MEMPHIS AND SHELBY COUNTY OFFICE OF PLANNING AND DEVELOPMENT
STAFF REPORT **13**

CASE NUMBER: P.D. 07-331
Companion Case **Z 07-118**

DEVELOPMENT NAME: **Kirby Gate Northwest Planned Development**

REQUEST: Reinstate P.D, formerly P.D. 97-353, to permit uses in the Townhouse Residential District and institutional uses such as a Assisted Living or a Nursing home. This request includes a specific plan for a Hospice Facility in Area A.

Site Plan for Area A – Hospice Facility

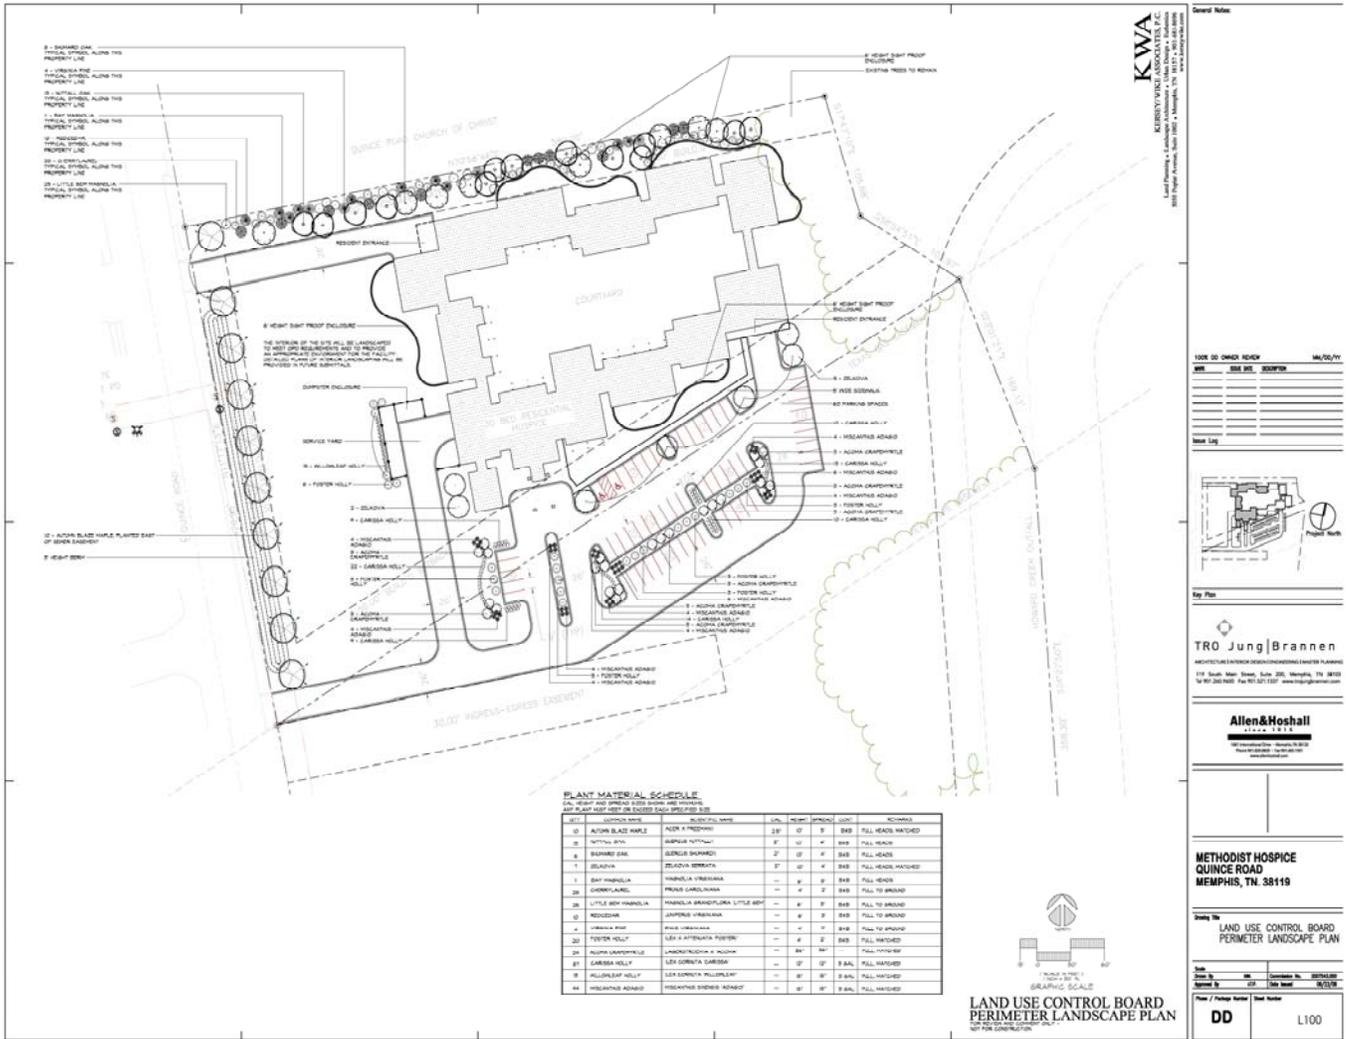
5. One recommended addition to the site plan is that a connection to Area B should be shown on this site plan. If Area B develops in a similar use, both a pedestrian and vehicular connection makes good sense. If Area B should develop in something other than a related use, the connection would not have to be continued.

Hospice Center – The plan for the Hospice Center shows a 30-bed residential hospice

facility. The site plan and landscape plan show an articulated building footprint which will breakup any long expanses of building. The buildings are designed to include a large internal court yard.

The landscape plan includes a berm along Quince Road and a detailed treatment along the north property line. Private gardens and open areas are also included in close proximity to the north, east, and west walls.

One recommendation addition to the site plan is that a connection to Area B should be shown on this site plan. If Area B develops in a similar use, both a pedestrian and vehicular connection makes good sense. If Area B should develop in something other than a related use, the connection would not have to be continued.

D. Provide a physical point of connection to Area B.
